Design of Labels for BD Compressors Marking on Compressor & Electronic Unit

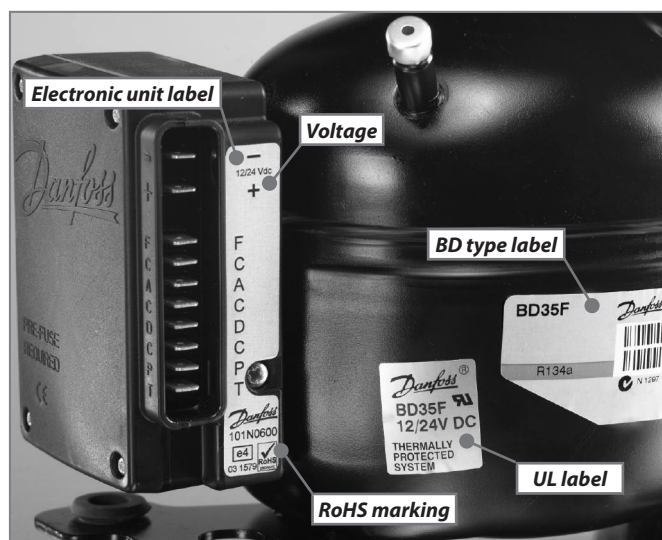
Introduction	All BD compressors are designed to meet specifications according to the EC type-approval certificate. In addition to that we have VDE and UL on most products. See <i>Product Bulletin (Technical Info) DEHC.EI.100.C</i> for further information. As we achieved VDE approval we were requested to make some changes on the marking of electronic and compressor which will be described in next section.	Date of manufacture	For the electronic unit, the code for date of manufacture is located on a label on the backside of the housing. For the compressor see <i>Product Bulletin (Technical Info) DEHC.EI.000.B</i> .
Valid from	2006 - updated 2009	Code numbers	No BD code numbers will be affected by the changes.
Compressor label	Nominal voltage has been removed and moved to the electronic unit. LBP/MBP marking has been removed. VDE marking will not appear on the label due to the fact that the compressor can be applied with non VDE approved electronic units.	Literature	Our literature (data sheets) has been updated with the new labelling.

Electronic unit label	The label contains the nominal supply voltage. Located between + and – terminal. The AC/DC electronic contains in addition the applied nominal AC voltage.		
UL label	Voltage has been re-established on the UL label and can also be found on the electronic unit.
